APPLICATION FOR A RESIDENTIAL SITE IMPROVEMENT PERMIT/ CONSTRUCTION AUTHORIZATION FOR AN ON-SITE WASTEWATER SYSTEM, NEW WELL INSTALLATION, OR REPAIR OF EXISTING WELL

TAX PARCEL NUMBER: 01525413
STREET ADDRESS: 9215 EDINBURGH AV
CITY: HUNTERSVILLE
STATE: NC ZIP: 28078
SUBDIVISION NAME: WESTMINSTER PARK
LOT #: 5 LOT SIZE (acres): 0.38

Re: Application for improvement permit for:
Property Location: 9215 Edinburg Ave
Health Department File Number: **11807B**

PROPOSED PLOT PLAN

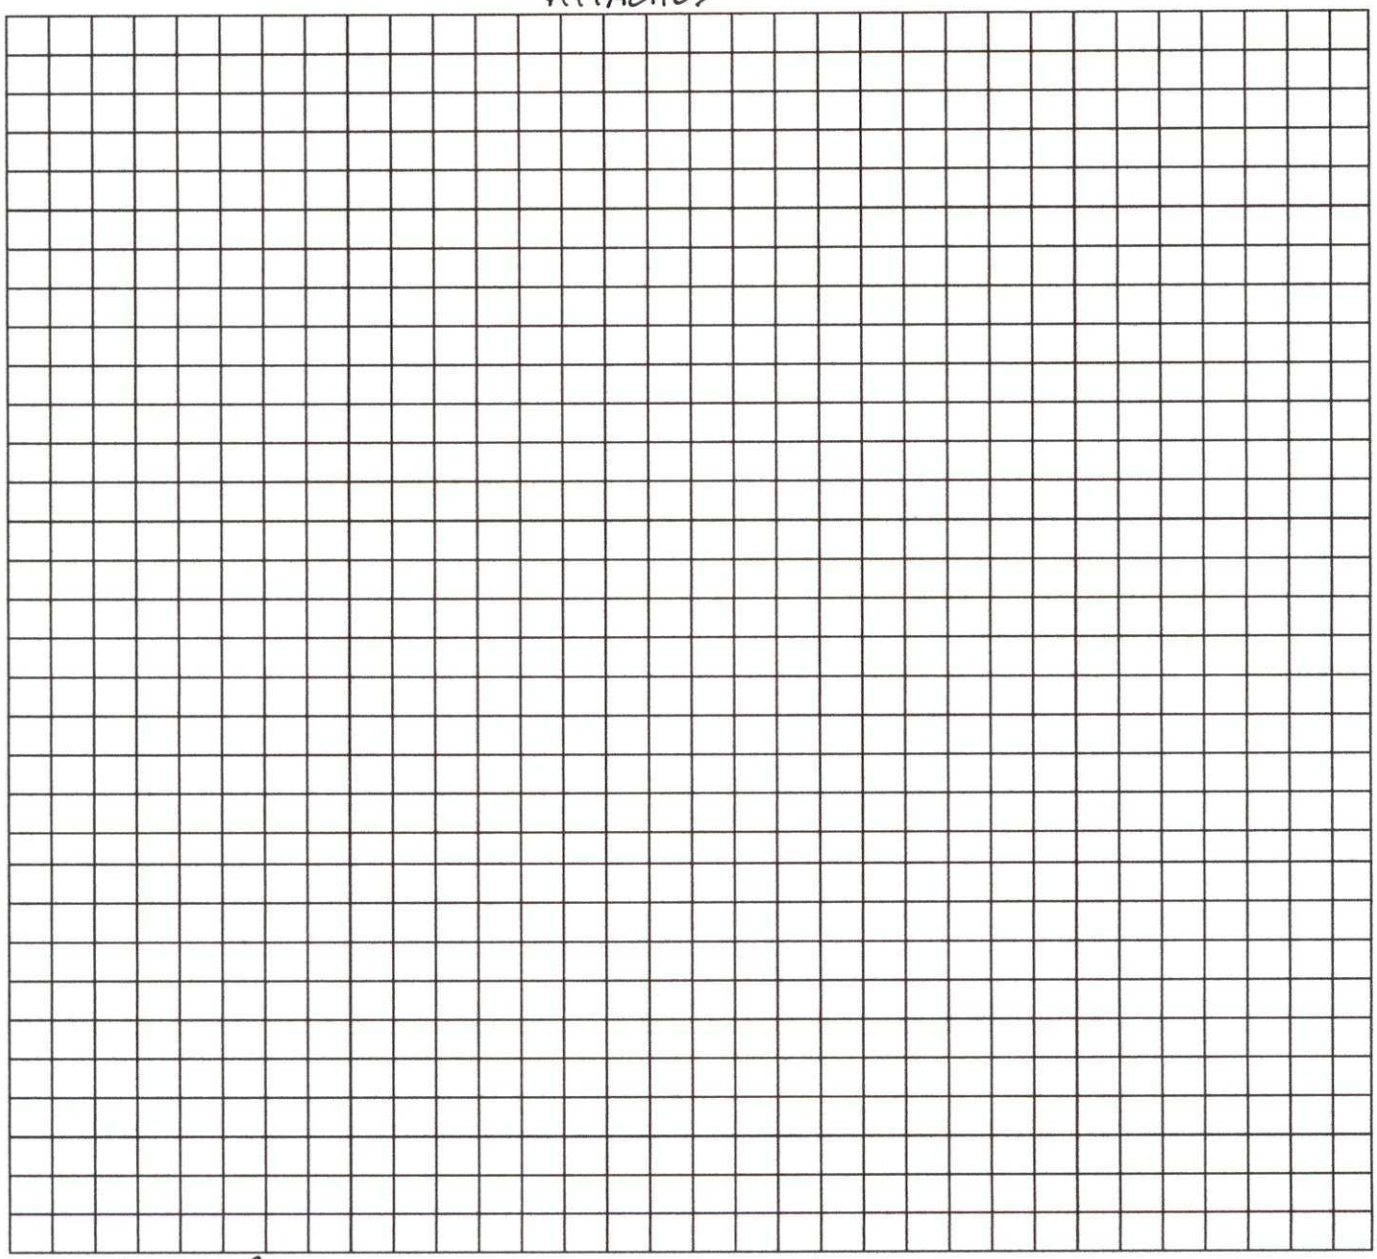
Based on the criteria set out in Title 15A, Subchapter 18A, of the North Carolina Administrative Code, Rules .1940 through .1948, the evaluation indicated that the site is **UNSUITABLE** for a ground absorption sewage system. Therefore, your request for an improvement permit is **DENIED.** A copy of the site evaluation is enclosed. The site is unsuitable based on the following:

- ☐ Unsuitable soil topography and/or landscape position (Rule .1940)
- ☐ Unsuitable soil characteristics (structure or clay mineralogy) (Rule .1941)
- ☐ Unsuitable soil wetness condition (Rule .1942)
- ☐ Unsuitable soil depth (Rule .1943)
- ☐ Presence of restrictive horizon (Rule .1944)
- ☒ Insufficient space for septic system and repair area (Rule .1945)
- ☐ Unsuitable for meeting required setbacks (Rule .1950)
- ☐ Other (Rule .1946)

The site evaluation included consideration of possible site modifications, and modified, innovative or alternative systems. However, the Health Department has determined that none of the above options will overcome the severe conditions on this site. A possible option might be a system designed to dispose of sewage to another area of suitable soil or off-site to additional property.

However, the site classified as **UNSUITABLE** may be classified as **PROVISIONALLY SUITABLE** if written documentation is provided that meets the requirements of Rule .1948(d). A copy of this rule is enclosed. You may hire a consultant to assist you if you wish to try to develop a plan under which your site could be reclassified as **PROVISIONALLY SUITABLE.**
